Westinghouse Containment Analysis Methodology – PWR LOCA Mass and Energy Release Calculation Methodology

WCAP-17721-NP-A
Revision 0

SUBJECT: FINAL SAFETY EVALUATION FOR WESTINGHOUSE ELECTRIC COMPANY (WESTINGHOUSE) TOPICAL REPORT (TR) WCAP-17721-P, REVISION 0, AND WCAP-17721-NP, REVISION 0, "WESTINGHOUSE CONTAINMENT ANALYSIS METHODOLOGY - PWR [PRESSURIZED WATER REACTOR] LOCA [LOSS-OF-COOLANT ACCIDENT] MASS AND ENERGY RELEASE CALCULATION METHODOLOGY"

Figure 5-7 Integrated Long-term Break Mass Release Comparison

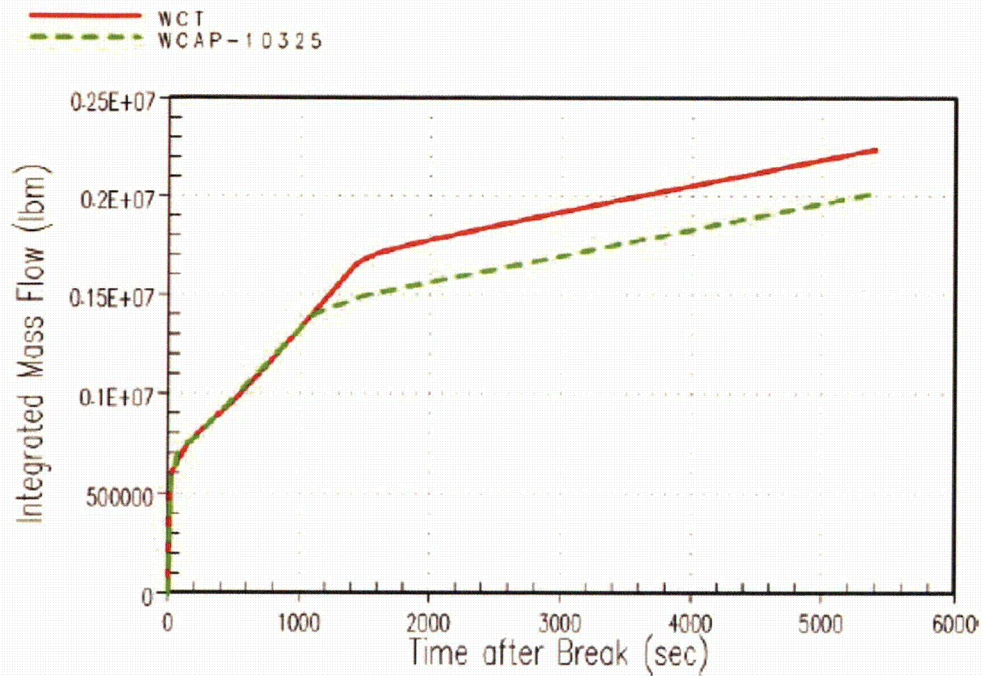
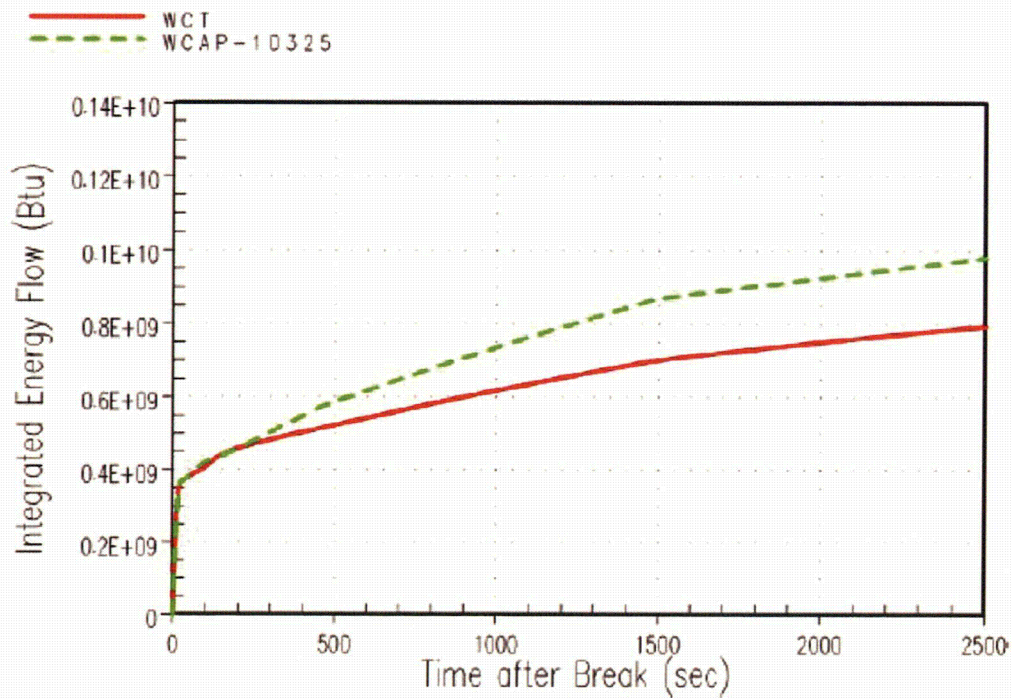
24-hr integrated mass and energy release via break	
<i>Please provide the integrated mass and energy release from break up to 24-hour (86400 seconds) for Figures 5-7 and 5-8; similarly, for DEHL case (Section 5.4).</i>	
SCVB-RAI-8, 24-hr Integrated Mass and Energy Release via Break (Reference 11)	
Disagreement Level	N/A
SE Section	Various
Comment	None
Reference of Response	1. SCVB-RAI-8, 24-hr Integrated Mass and Energy Release via Brea (Reference 13)

Figure 6-2 Long-term Containment Pressure Comparison

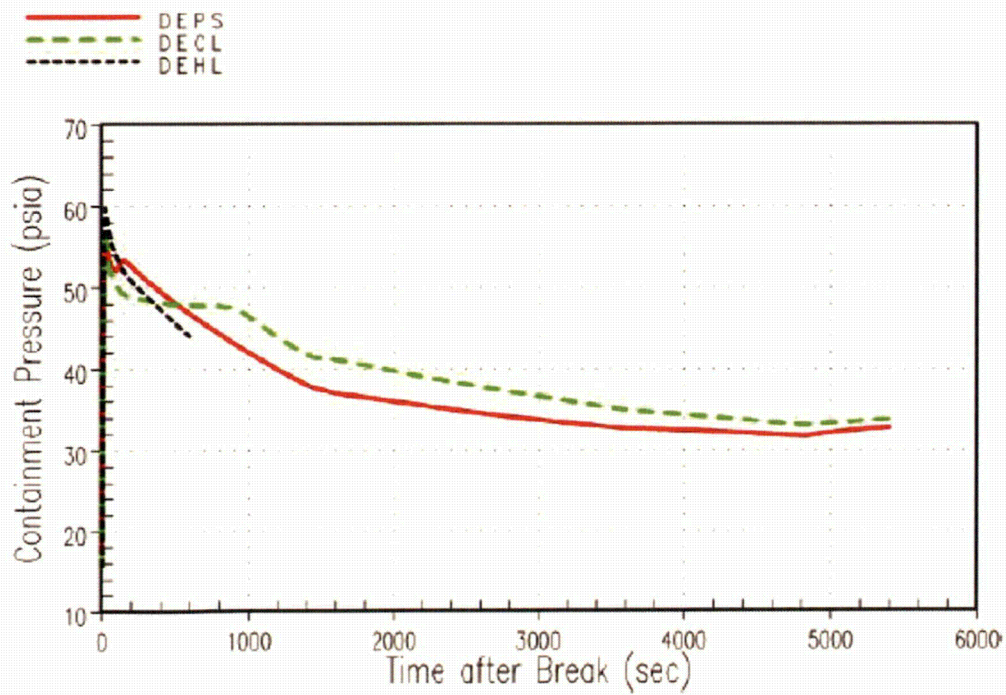
24-hr containment pressure	
Figure 6-2 shows that the containment pressure, especially for double-ended pump suction (DEPS) case, is rising after 5000 seconds. Provide 24-hour (86400 seconds) containment response for both DEPS (Section 5.3) and double-ended hot leg (DEHL) (Section 5.4) cases. Provide the analysis procedure (methodology) to assure the adequacy of containment heat removal system by demonstrating, for example, that the containment pressure will be below 50 percent of peak pressure after 24-hour into LOCA (NUREG-0800, "Standard Review Plan," Section 6.2.2, "Containment Heat Removal Systems.").	
SCVB-RAI-7, 24-hr Containment Pressure (Reference 11)	
Disagreement Level	N/A
SE Section	Various
Comment	None
Reference of Response	1. SCVB-RAI-7, GOTHIC Running In Parallel With WC/T (Reference 13)
